Completing the draft & analysis of comments on D1.1

Sanjay Kasturia
Editor-in-chief, 802.3an

Transmit PSD Mask Definition

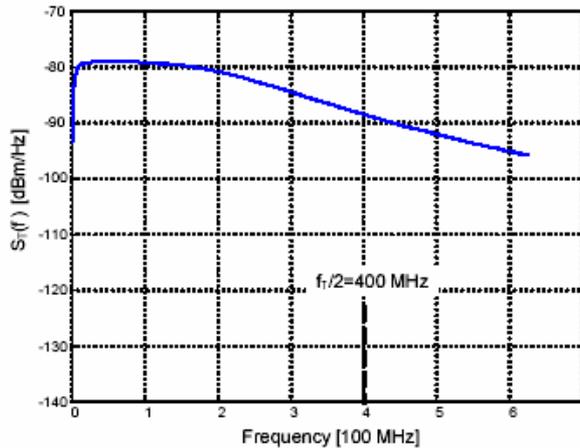
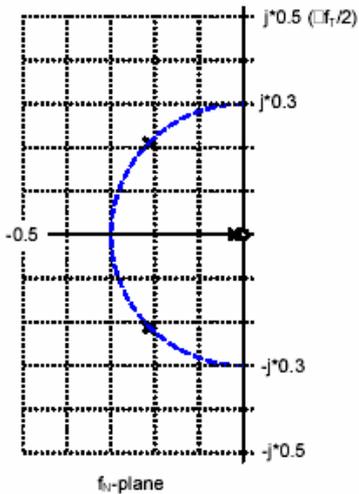
- Comment submitted to eliminate time domain pulse templates
 - PSD is claimed to be adequate
